December 11, 2023

Husmann Corporation
12999 St. Charles Rock Rd.
Bridgeton, MO 63044
Office (314) 291-2000
www.husmann.com

Re: AHRI Comments in Response to Energy Conservation Standards for Commercial Refrigerators, Freezers, and Refrigerator-Freezers, Notice of Proposed Rulemaking [EERE-2017-BT-STD-0007]

Figure 1: Normalized energy use for Hussmann’s highest volume five-deck dairy display case in the VOP.RC.M equipment class from 1985 – current.

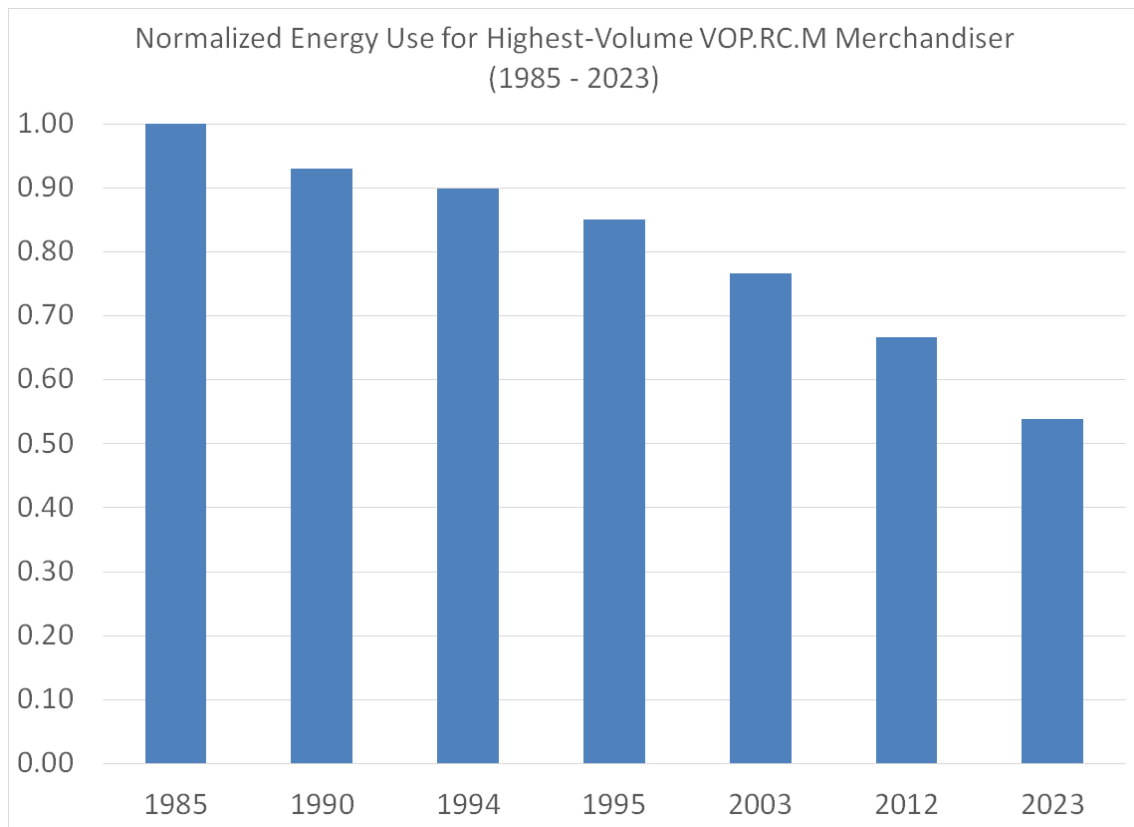
Hussmann did much work to meet the 2017 limits for several equipment classes and have continuously improved case energy performance to stay competitive in the industry regardless of DOE regulations—see Figure 1 below. Since DOE 2017, all cases are shipping with ECM motors, LED lights, and optimized air curtains/doors and insulation as standard. Hussmann is not clear where else cases can be improved to meet such drastic cuts in energy consumption.

Below is the energy efficiency evolution of Hussmann's highest volume dairy case from 1985 – 2023. All data for this chart is based on published application data from the time and calculated according to AHRI 1200. As shown, energy consumption has been reduced by 46+% over this time period for this equipment class. Other equipment classes like VCT.RC.L have similar efficiency improvements.

Hussmann has been continuously innovating for years because the marketplace demands it. These efficiency improvements have been a result of working with retailers to utilize technologically feasible components which the retailers support. Advances in efficiency driven and supported by our customers (e.g., EC motors and LED lighting) have payback periods that the market readily accepts.
